Well Name: SCHLITZ FED COM	Well Location: T25S / R26E / SEC 16 / SESE /	County or Parish/State:
Well Number: 204H	Type of Well: CONVENTIONAL GAS WELL	Allottee or Tribe Name:
Lease Number: NMNM19836	Unit or CA Name:	Unit or CA Number:
US Well Number: 3001549023	Well Status: Approved Application for Permit to Drill	Operator: TAP ROCK OPERATING LLC

Drilling Operations Plan
 Schlitz Fed Com #204H
 Tap Rock Operating, LLC
 SHL 672' FSL & 913' FEL, Sec. 16
 BHL 200' FNL & 660' FEL, Sec. 9
 T. 25S., R. 26E., Eddy County, NM

PECOS DISTRICT DRILLING CONDITIONS OF APPROVAL

Updated COAs per sundry approved on 03/21/2022. Includes surface string depth adjustment and 3-string / 4-string alternate casing design.

5,000 psi BOP Stack

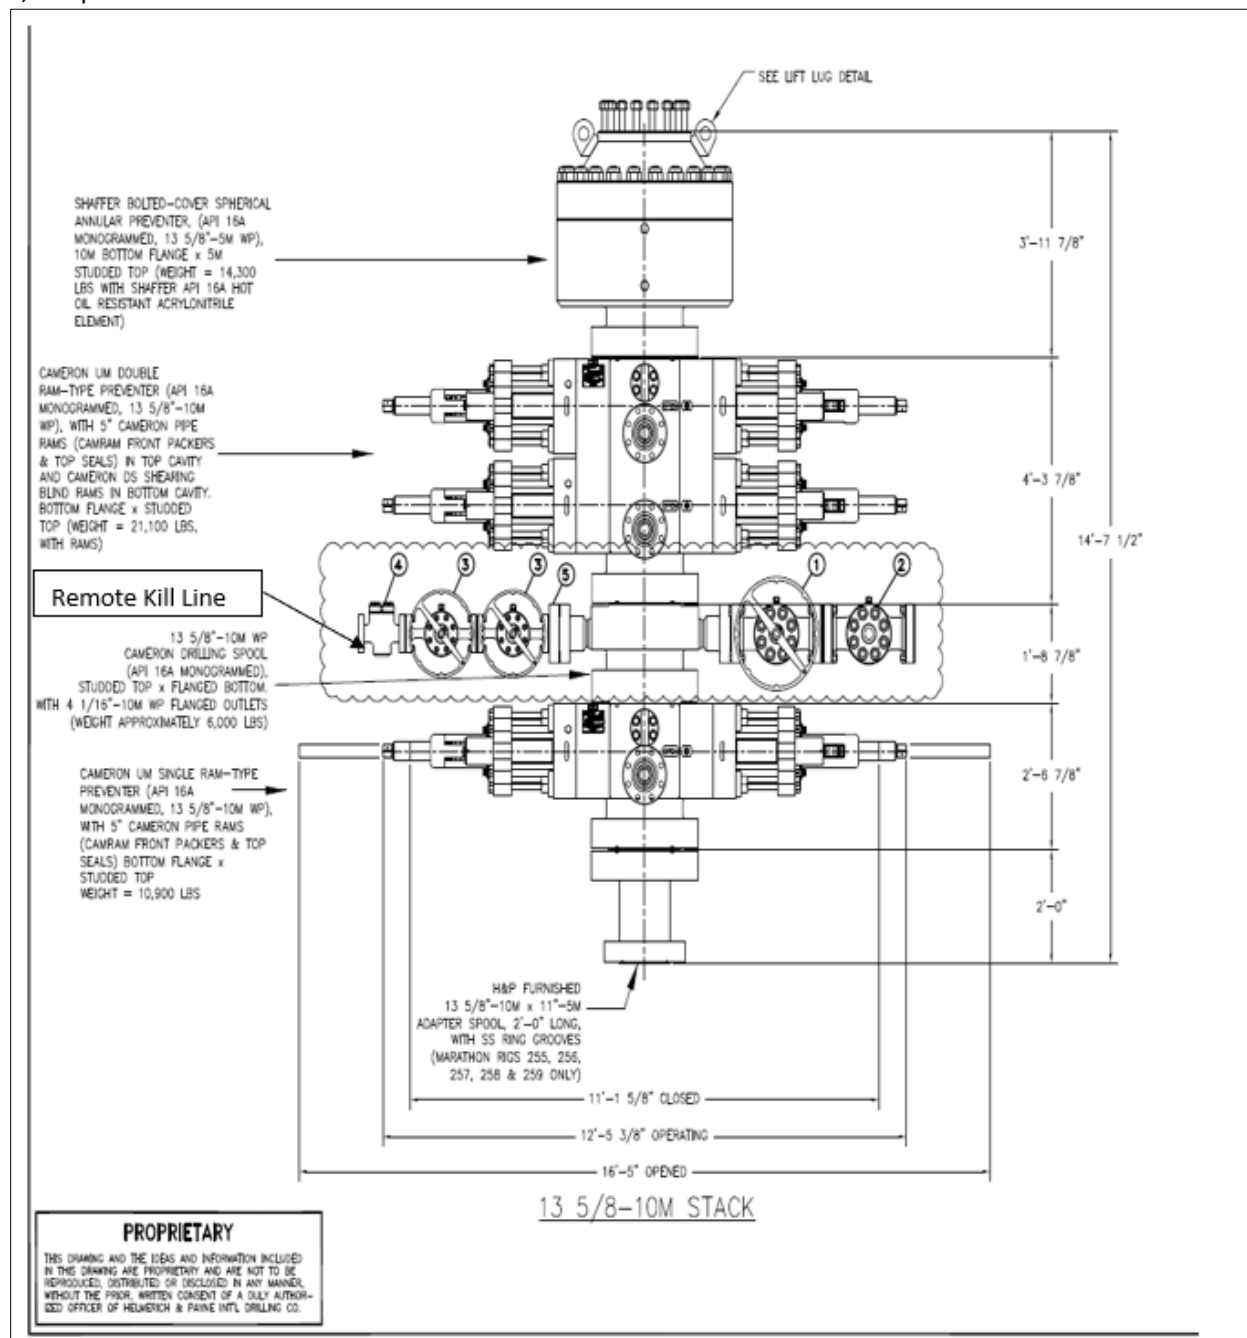
2. Operator has proposed a multi-bowl wellhead assembly. This assembly will only be tested when installed on the surface casing. Minimum working pressure of the blowout preventer (BOP) and related equipment (BOPE) required for drilling below the surface casing shoe shall be **5000 (5M)** psi.

3. 5M or higher system requires an HCR valve, remote kill line and annular to match. The remote kill line is to be installed prior to testing the system and tested to stack pressure.

Multi-bowl Wellhead

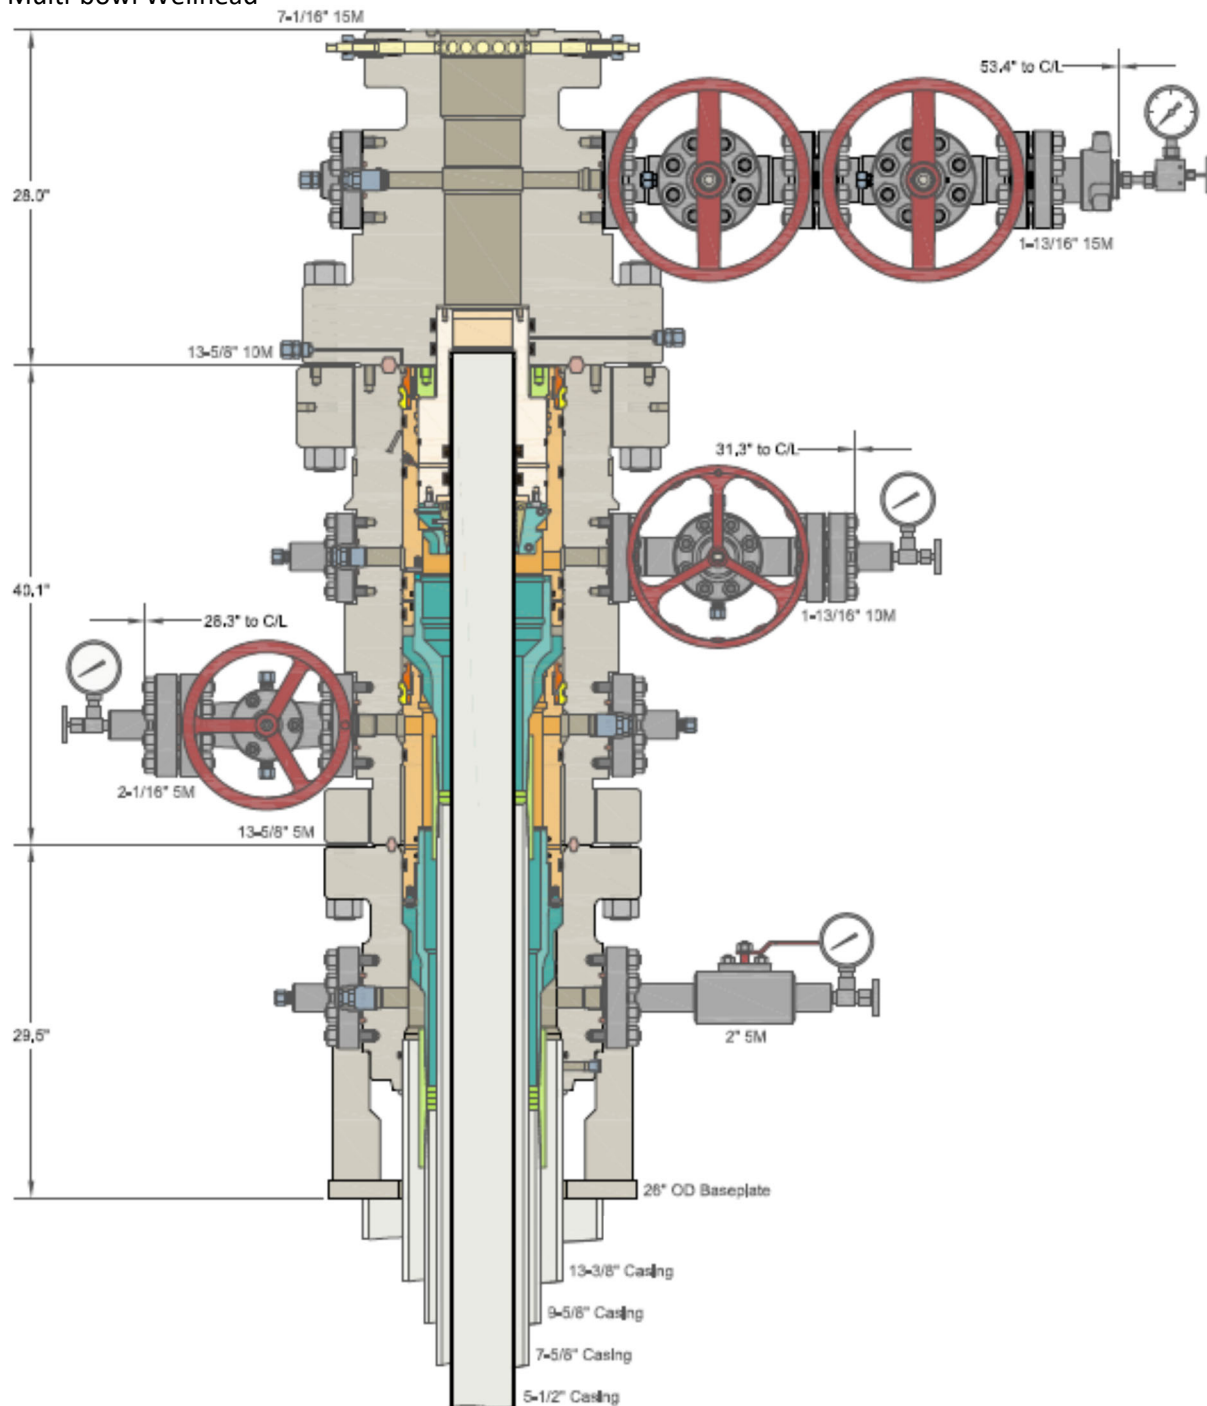
- a. Wellhead shall be installed by manufacturer's representatives, submit documentation with subsequent sundry.
 - b. If the welding is performed by a third party, the manufacturer's representative shall monitor the temperature to verify that it does not exceed the maximum temperature of the seal.

- c. Manufacturer representative shall install the test plug for the initial BOP test.
 - d. If the cement does not circulate and one inch operations would have been possible with a standard wellhead, the well head shall be cut off, cementing operations performed and another wellhead installed.

- e. Whenever any seal subject to test pressure is broken, all the tests in OOGO2.III.A.2.i must be followed.
